THE GLIDING FEDERATION OF AUSTRALIA

GFA/AD 248

AIRWORTHINESS DIRECTIVE GLIDERS/POWERED SAILPLANES

Subject: Forward trim weight attachment bracket

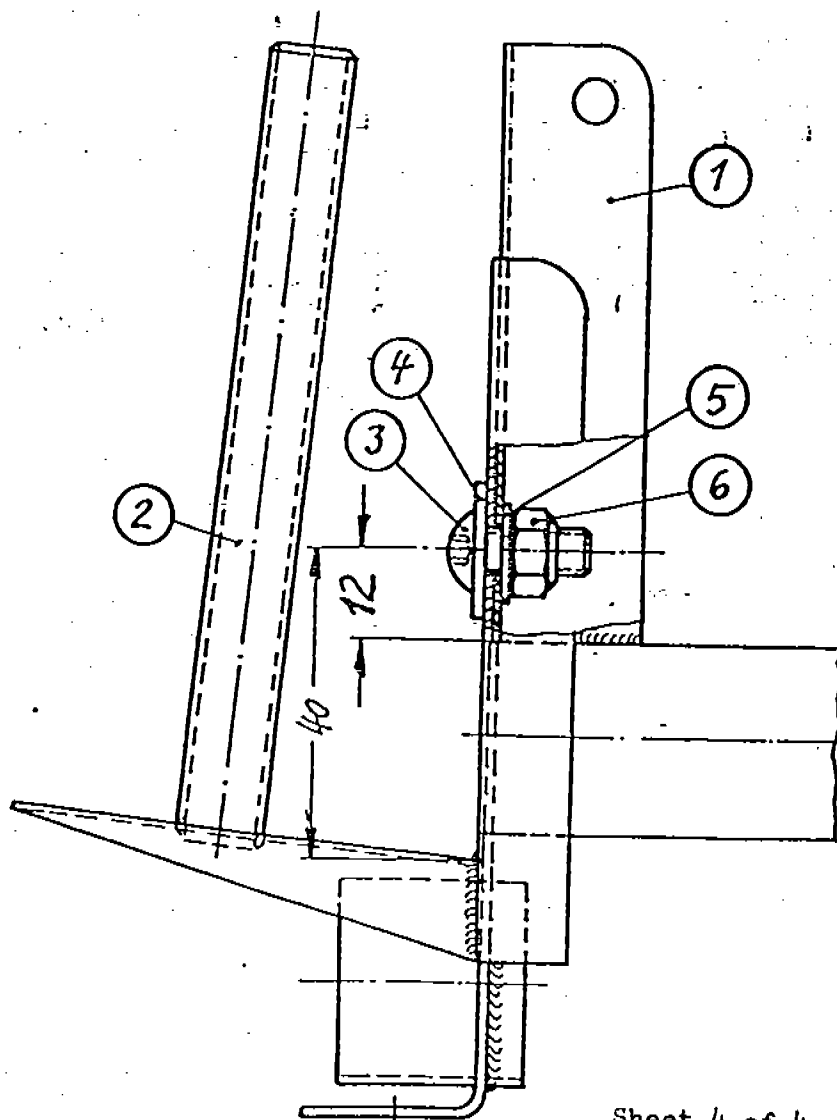
Only fitting hole is out of given range:

- a) Take canopy off.
- b) Dismount canopy gas strut at forward end.
- c) Fit bracket provisionally using existing hole.
- d) Drill new hole of 6.1 mm in diameter (o.24 in, use drill of drill number size C) 12 mm (o.5 in) above square tube of pedal guide.
- e) Mount bracket according to drawing 4BR-48 using large washer, connect gas strut.

Cracks have been found:

- a) Set circular cutout of new bracket onto tube of pedal guide.
- b) Mark hole on bracket.
- c) Drill hole, see above under d)
- d) Mount bracket according to drawing 4BR-48 using large washer.

If both possibilities apply, a new bracket must be used and a new hole drilled into pedal guide.

Material and
Instructions: Disassemble bracket and check for cracks. (4 mm hex key).
Case 1: No cracks detectable and fitting hole is 40 to 52 mm
(1.57 to 2 in) above trim weight support - reassemble
bracket using large washer according to drawing
4BR-48.
Case 2: Cracks could be found or fitting hole is above given
range - proceed as detailed in Fitting Instruction
for 4BR-48.
